DeKalb County Zoning Board of Appeals

Planning Department Staff Analysis

N2. Case No: A-26-1248173

Project Name: 7461 Union Grove Road – Detached Accessory Dwelling Unit

ITEM	IMPERVIOUS
DRIVEWAY	4330 SQ FT
HOME	2826 SQ FT
PORCH	80 SQ FT
PROPOSED DWELLING UNIT	902 SQ FT
TOTAL	8138 SQ FT
IMPERV. LIMIT	35%
PROP. IMPERV.	6.2%

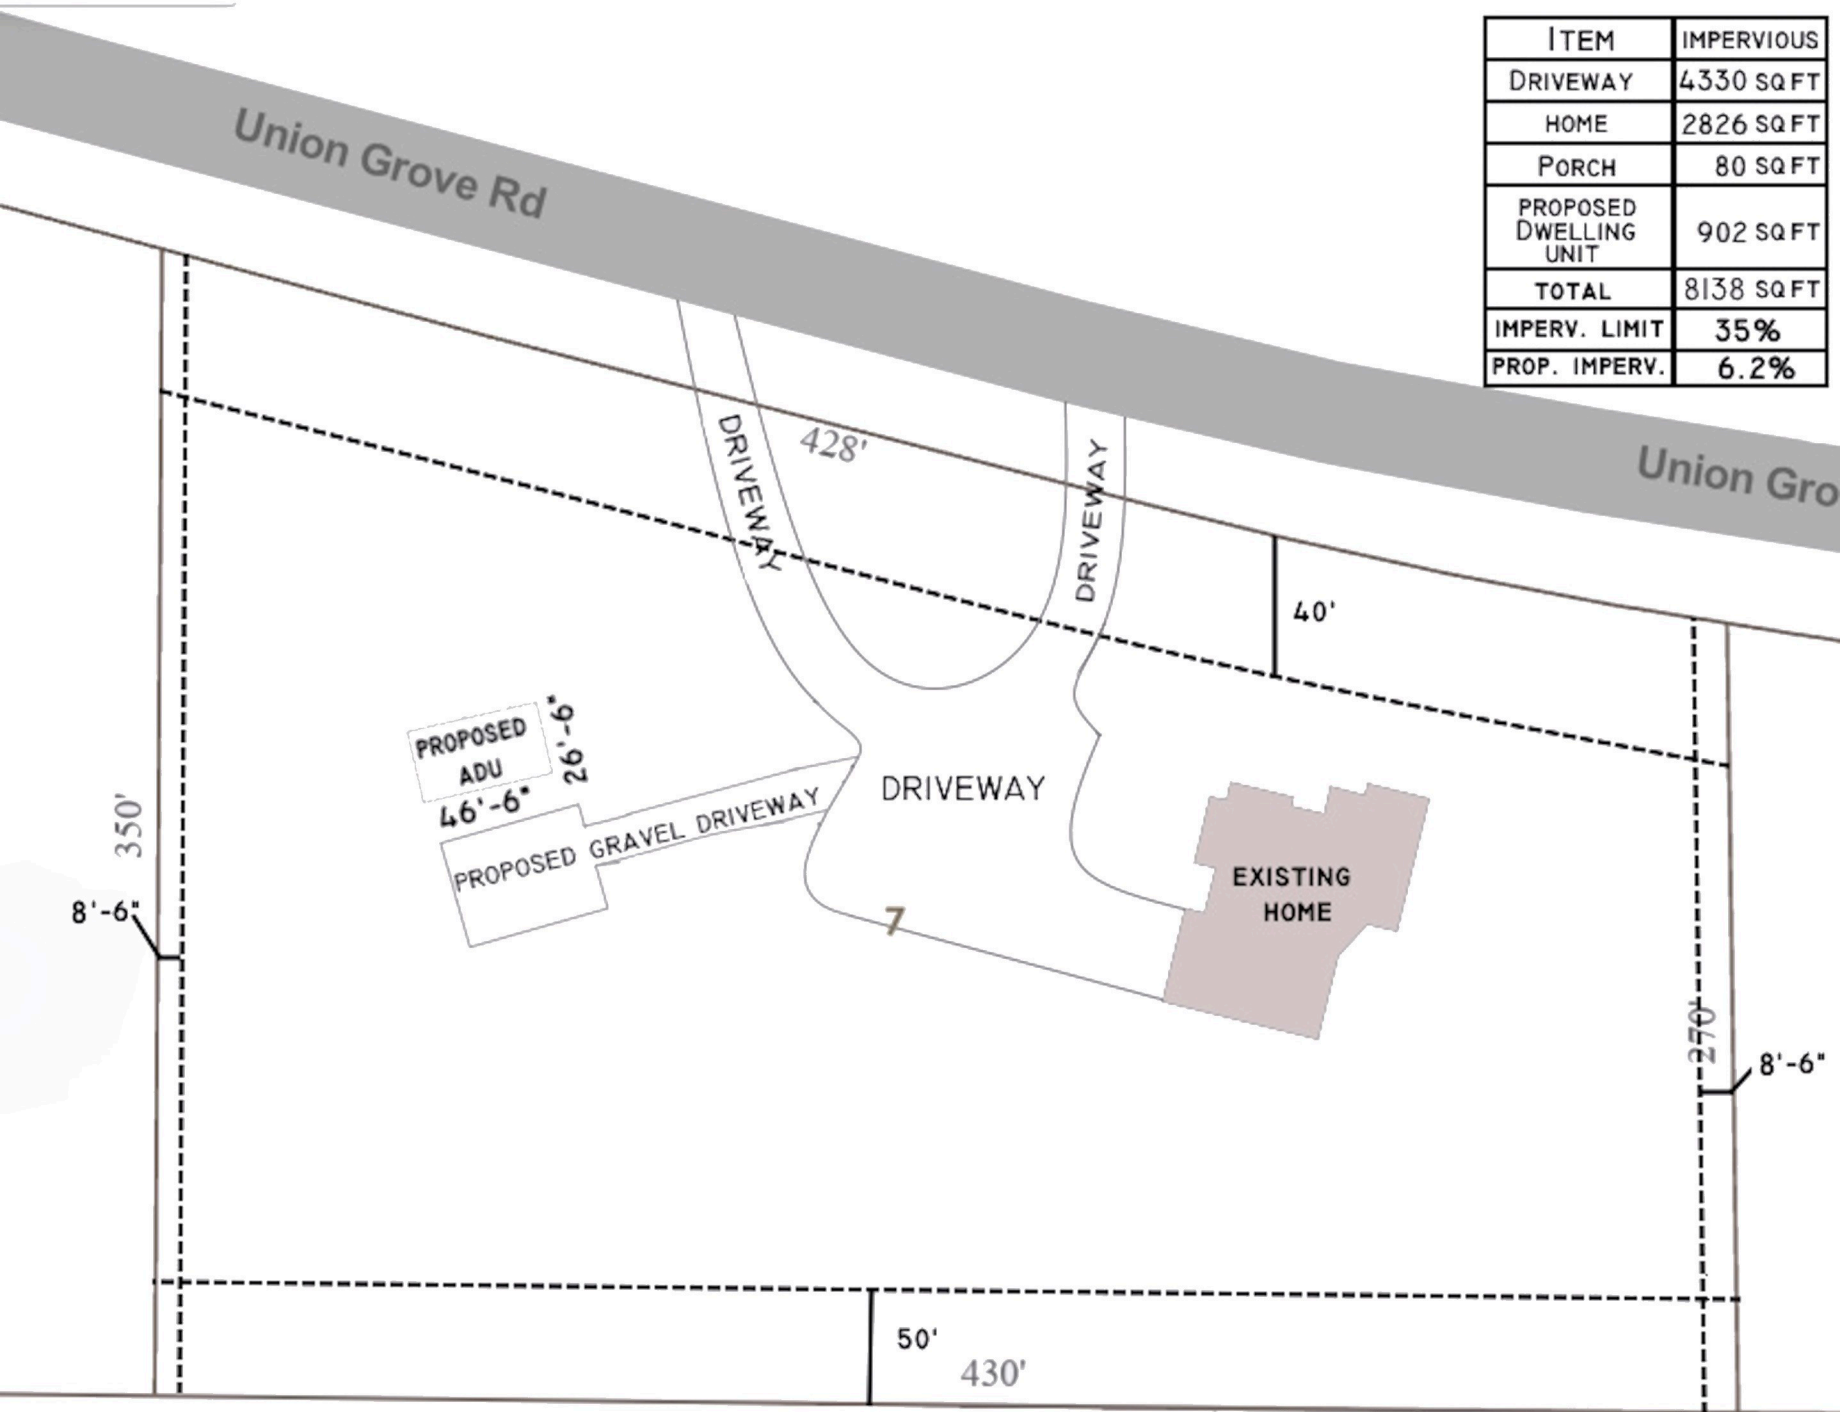
The submitted plans list the ADU at 902 square feet and 15 feet 9 inches in height, with proposed impervious coverage of approximately 6.2 percent. The Zoning Ordinance limits an ADU to 900 square feet of heated floor area and requires one additional paved off-street parking space. The packet does not include a topographic survey or septic plan; compliance with the floor-area, parking, septic, setback, grading, drainage, and other applicable requirements must therefore be confirmed during permit review. The variance request shall only be limited to the scope of building location and all other standards will be enforced in the permitting process.

The proposed ADU would be placed west of the principal residence and connected to the existing driveway by a new driveway. The site plan shows the ADU outside the principal residence's conventional rear yard but within the broad open area between the western property line and the existing home. The land directly behind the residence is constrained by grade changes, retaining walls, exposed granite and rock, mature and fruit trees, limited construction access, septic infrastructure, an accessibility ramp, and the elevated rear/basement condition of the house.

The plan's 902-square-foot notation cannot be treated as approval of an unrequested size variance; compliance with the 900-square-foot heated-area cap shall be enforced at the permit stage which follows the variance stage. With that limitation and substantial conformance to the submitted placement, the requested relief is the minimum necessary and does not confer a special privilege.

Approval should be narrowly limited to the submitted placement and should not be construed to grant relief from the 900-square-foot heated-floor-area limit, parking requirements, septic review, setbacks, building codes, stormwater requirements, or any other ordinance standard. The site conditions cited by the applicant should be confirmed during permit review, and the proposed ADU should remain subordinate to the principal residence and residential in use and appearance.

1. The following information about this variance shall be noted on any site plan prepared for the subject property: case number, approval date, type of variance, and all conditions of approval.
2. Permit drawings shall be substantially consistent with the ADU location, building footprint, floor plan, elevations, height, driveway connection, and related improvements shown in the application packet for A-26-1248173. Any material relocation of the ADU or material change to the approved site layout shall require review and approval by the Zoning Board of Appeals.
